Access Compliance Report

Public Rights-of-Way

Intersection ID: 10030604	Main Street: LOMA_LINDA_LN	Cross Street: N/A	Location: W
ADA ID: 3FBEC8F256F9	Ramp Type: Perp	Initial Pass/Fail: Fail	Overall Compliance: No
Severity Score: 12.5			
Codes/Mitigation Info/Possible Solution		Field Measurements/Component Compliance

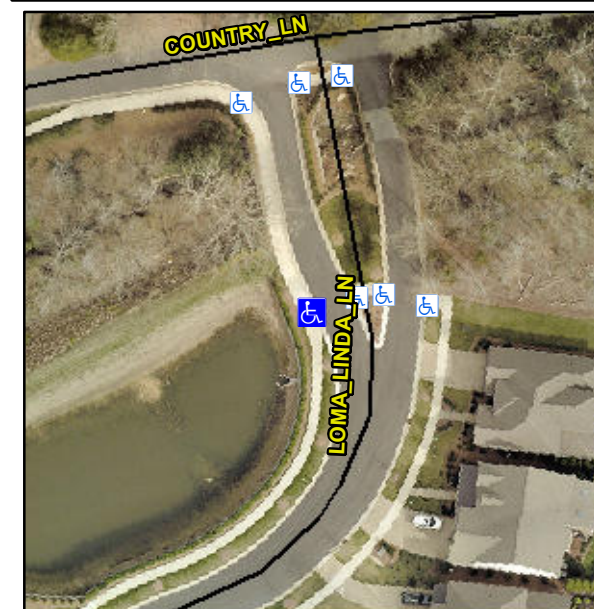
Not Found, R304.5.3

Compliance	Description	Data	Compliance	Description	Data
N/A	Ramp Length (in)	83.0	Yes	Ramp Slope (%)	8.2
Yes	Ramp Width (in)	48.0	No	Ramp XSlope (%)	6.2
N/A	Flare Type LT	N/A	N/A	Flare Type RT	N/A
N/A	Flare Slope LT (%)	N/A	N/A	Flare Slope RT (%)	N/A
N/A	Flare Traversable LT?	N/A	N/A	Flare Traversable RT?	N/A
N/A	Landing Length (in)	N/A	N/A	DWS Provided?	N/A
N/A	Landing Width (in)	N/A	N/A	DWS Contrast?	N/A
N/A	Landing Slope (%)	N/A	N/A	DWS Length (in)	N/A
N/A	Landing X Slope (%)	N/A	N/A	DWS Full Width?	N/A
N/A	Landing Curb? (Y/N)	N/A	N/A	DWS Offset (in)	N/A
N/A	Shared Landing?	N/A			
N/A	Gutter Ponding?	N/A	N/A	Gutter Slope (%)	N/A
N/A	Gutter Lip Ht (in)	N/A	N/A	Gutter X Slope (%)	N/A
N/A	Painted X Walk1?	No	N/A	Painted X Walk2?	N/A
	X Walk 1 Direction	To E		X Walk 2 Direction	N/A
N/A	X Walk 1 Width (in)	N/A	N/A	X Walk 2 Width (in)	N/A
	X Walk 1 Slope (%)	1.2		X Walk 2 Slope (%)	N/A
	X Walk 1 X Slope (%)	3.7		X Walk 2 X Slope (%)	N/A

Remove & Replace Entire Ramp.
